SACRAMENTO MUNICIPAL UTILITY DISTRICT □ 6201 S Street, Box 15830, Sacramento, California 95813; (916) 452-3211

DOCKET NO. 50-312
LICENSE NO. DPR-54
SPECIAL REPORT NO. 82-05

In accordance with Rancho Seco Nuclear Generating Station Technical Specifications Section 6.9.5.B.1 and 10 CFR 50 Appendix K, the Sacramento Municipal Utility District hereby submits a report of the Reactor Building Inspections performed during July of 1982. A summary of discrepancies is listed below. Work Requests have been issued to correct these items.

ENCLOSURE 6.1 (Continued)

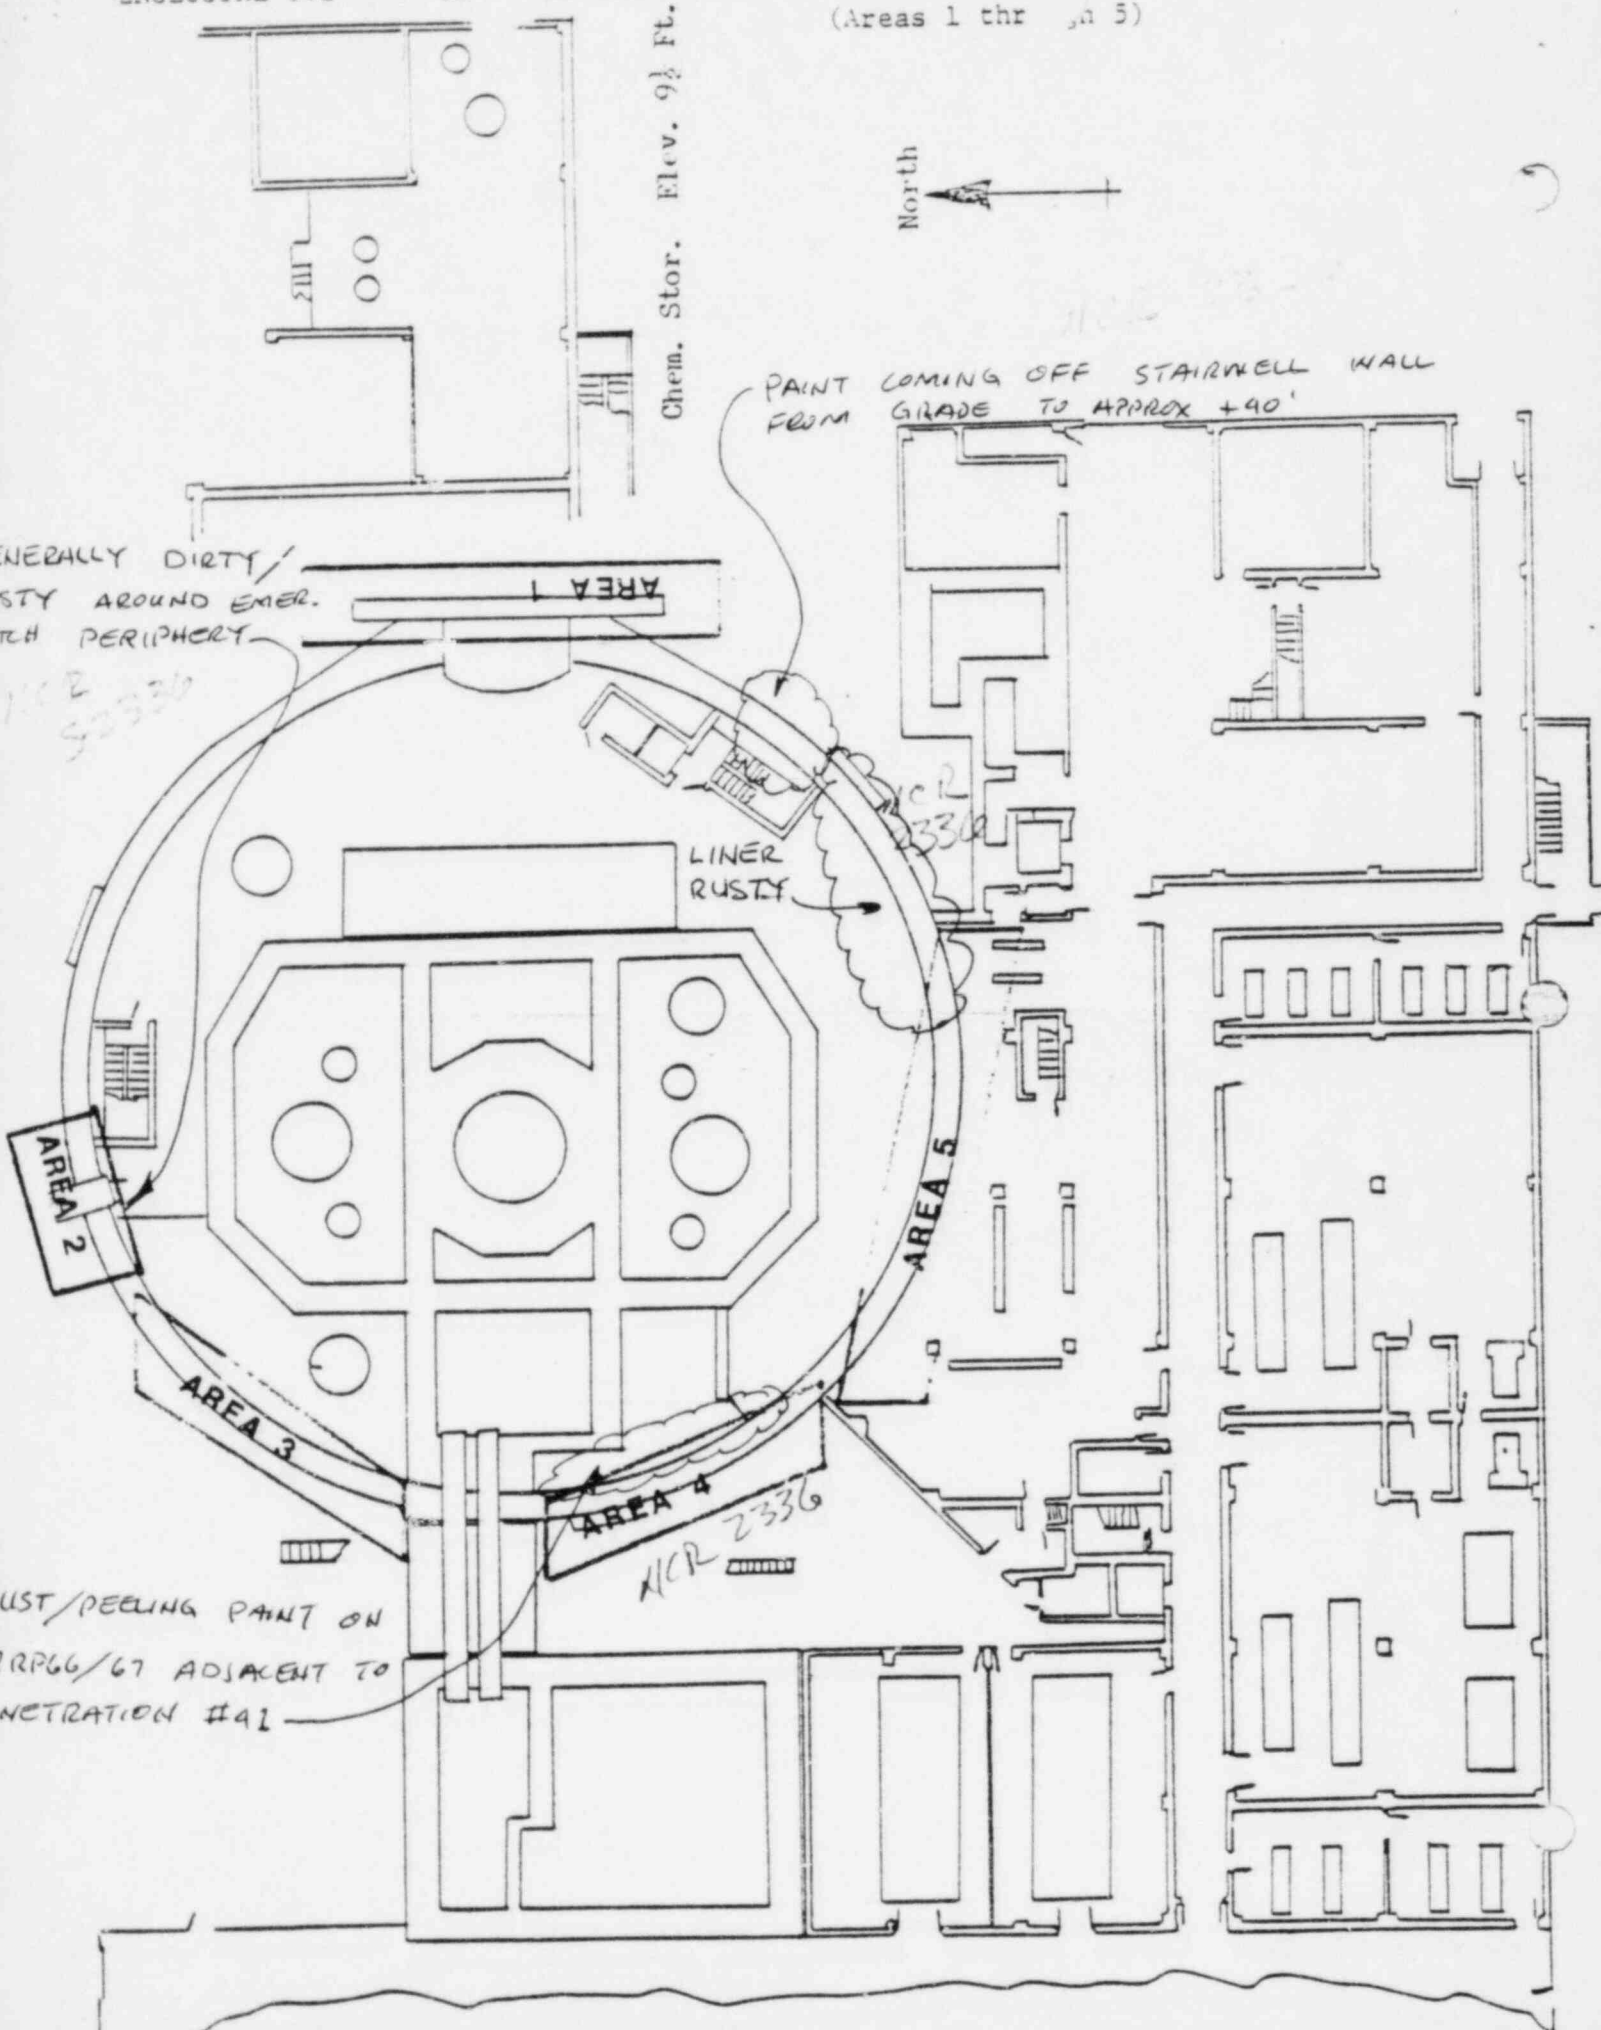
PAINT COMING OFF STAIRWELL WALL FROM GRADE TO APPROX +90'

GENERALLY DIRTY / RUSTY AROUND EMER. EXIT PERIPHERY

LINER RUSTY

RUST/PEELING PAINT ON TRPG6/67 ADJACENT TO PENETRATION #41

SPECIFIC AREAS OF EXTERIOR SURFACES TO BE INSPECTED
(Areas 6 and 7)

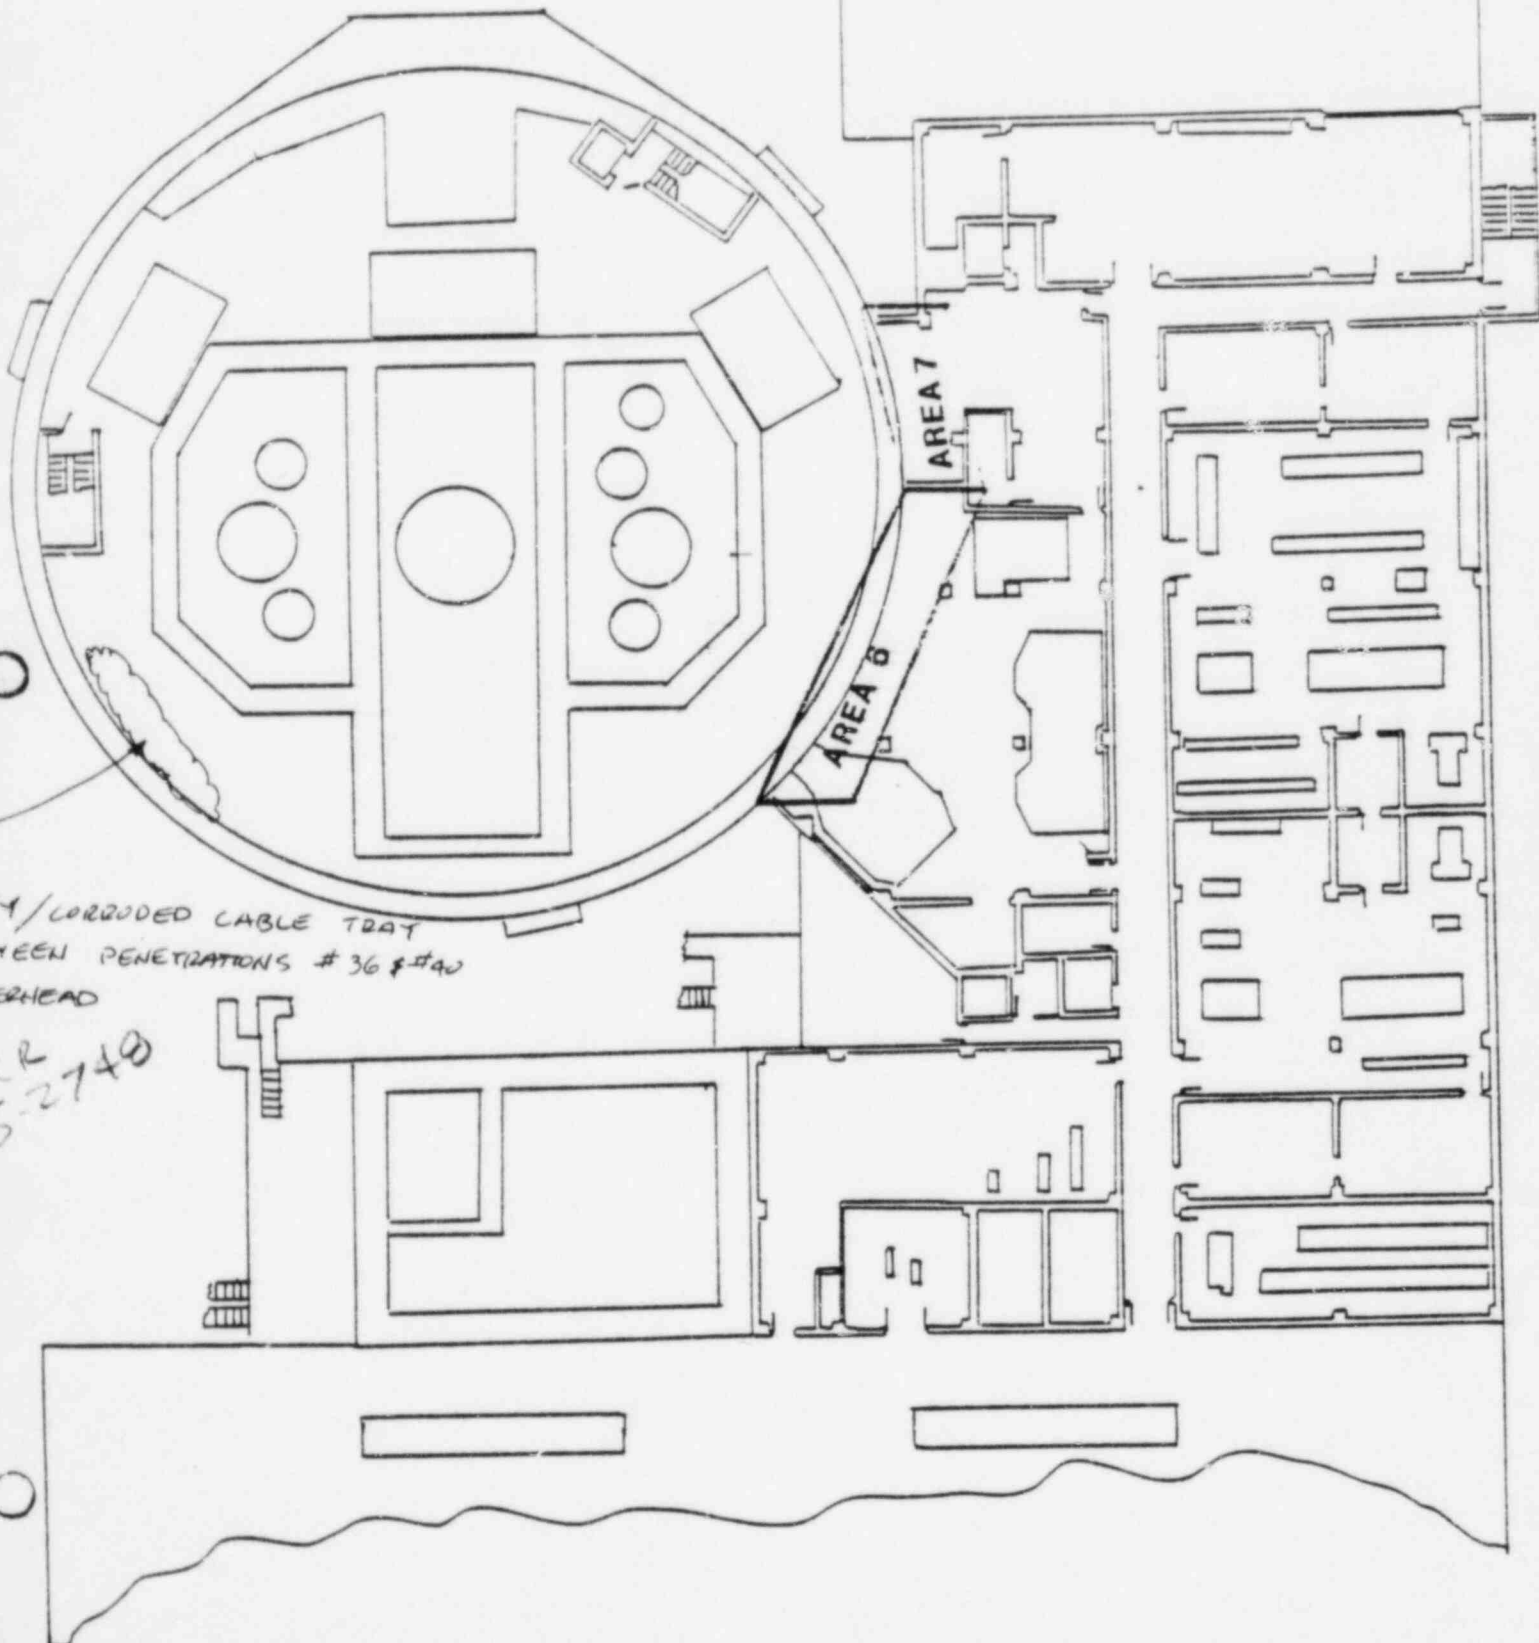
UNSTY/LOADED CABLE TRAY
BETWEEN PENETRATIONS #36 & #40
OVERHEAD

SPECIFIC AREAS OF EXTERIOR SURFACES TO BE INSPECTED
(Areas 10 and 11)

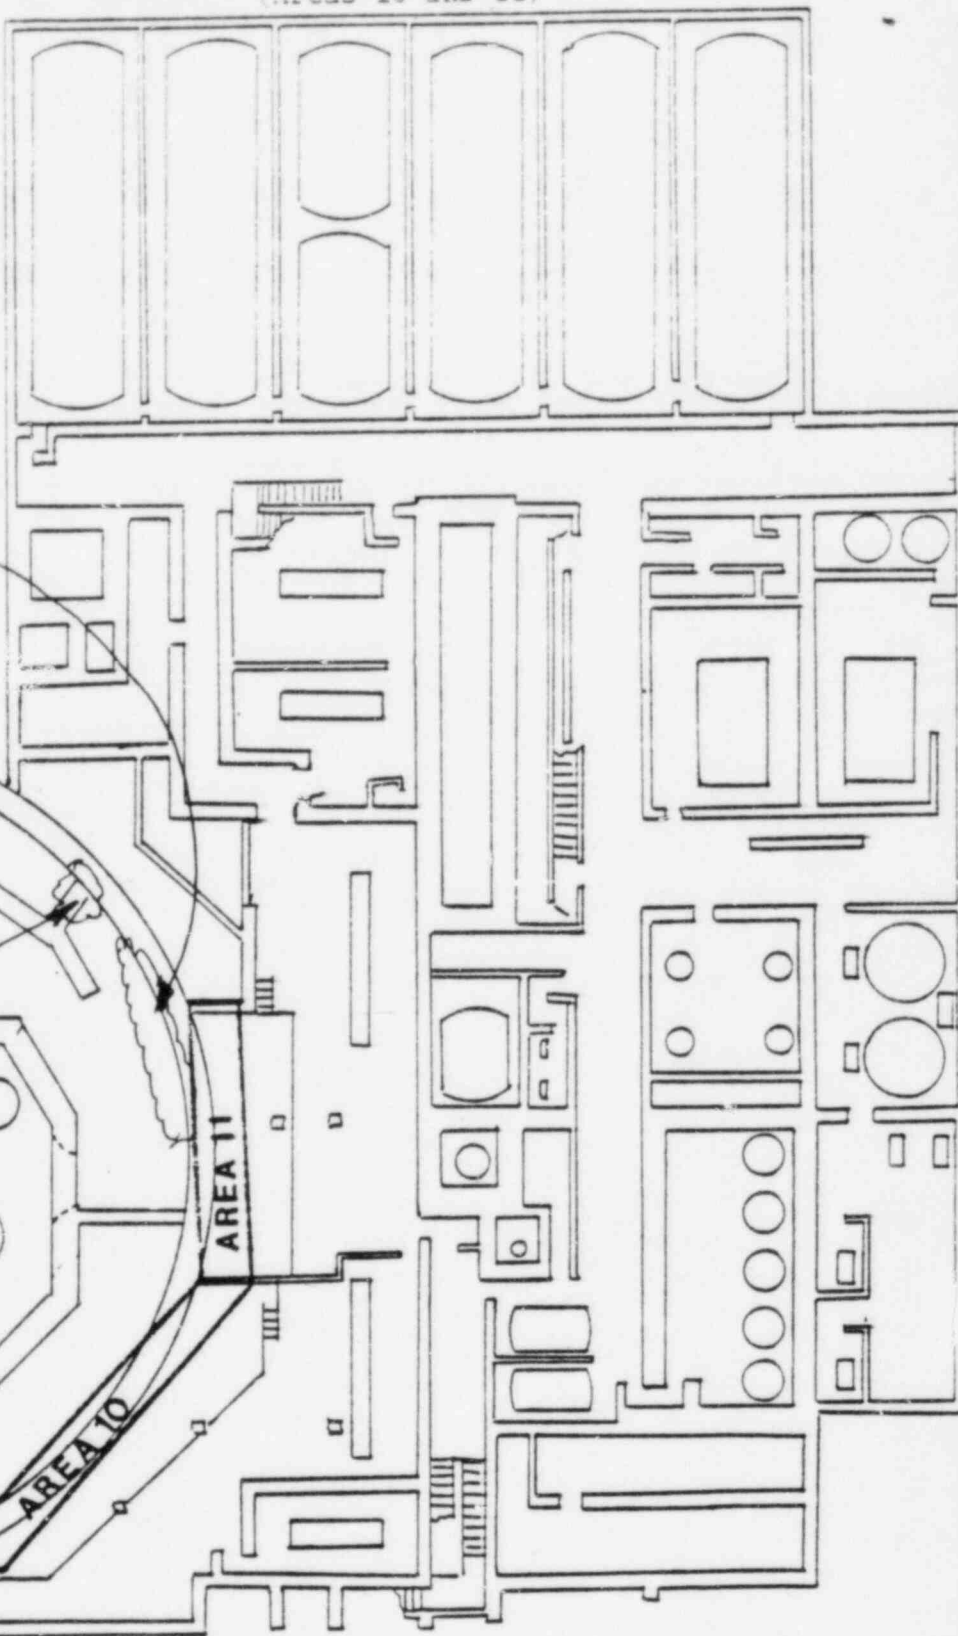
RUSTY/CORRODED FLANGES &
PEELING PAINT ON MUCH NSW
PIPING.

NCR
S-2326
BADLY RUSTED
BEHIND BULKHEAD
